# Access Compliance Report

## Public Rights-of-Way

Intersection ID: 15178	Main Street: DILWORTH_RD_EAST	Cross Street: IDEAL_WY	Location: SW
ADA ID: A3ED3E376822	Ramp Type: Perp	Initial Pass/Fail: Fail	Overall Compliance: No
Severity Score: 1.25			
Codes/Mitigation Info/Possible Solution		Field Measurements/Component Compliance

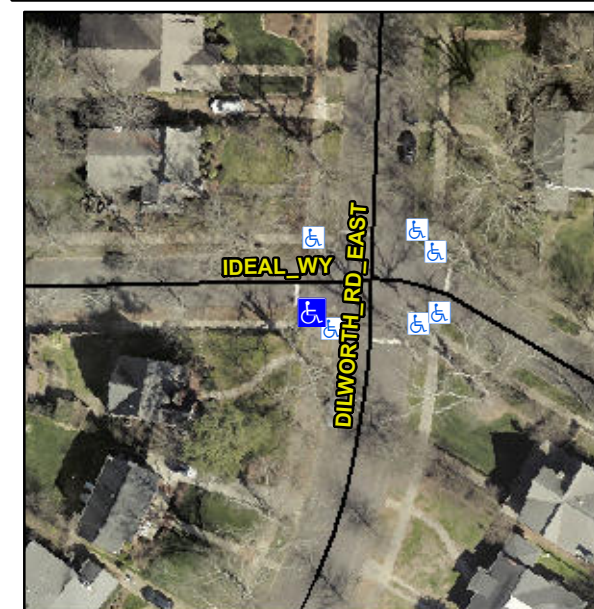
**Not Found, R304.5.3**

Compliance	Description	Data	Compliance	Description	Data
N/A	Ramp Length (in)	77.0	Yes	Ramp Slope (%)	8.0
Yes	Ramp Width (in)	60.0	No	Ramp XSlope (%)	4.3
N/A	Flare Type LT	N/A	N/A	Flare Type RT	N/A
N/A	Flare Slope LT (%)	N/A	N/A	Flare Slope RT (%)	N/A
N/A	Flare Traversable LT?	N/A	N/A	Flare Traversable RT?	N/A
N/A	Landing Length (in)	N/A	N/A	DWS Provided?	N/A
N/A	Landing Width (in)	N/A	N/A	DWS Contrast?	N/A
N/A	Landing Slope (%)	N/A	N/A	DWS Length (in)	N/A
N/A	Landing X Slope (%)	N/A	N/A	DWS Full Width?	N/A
N/A	Landing Curb? (Y/N)	N/A	N/A	DWS Offset (in)	N/A
N/A	Shared Landing?	N/A			
N/A	Gutter Ponding?	N/A	N/A	Gutter Slope (%)	N/A
N/A	Gutter Lip Ht (in)	1.0	N/A	Gutter X Slope (%)	N/A
N/A	Painted X Walk1?	No	N/A	Painted X Walk2?	N/A
	X Walk 1 Direction	To N		X Walk 2 Direction	N/A
N/A	X Walk 1 Width (in)	N/A	N/A	X Walk 2 Width (in)	N/A
	X Walk 1 Slope (%)	3.7		X Walk 2 Slope (%)	N/A
	X Walk 1 X Slope (%)	1.9		X Walk 2 X Slope (%)	N/A

**Remove & Replace Entire Ramp.**
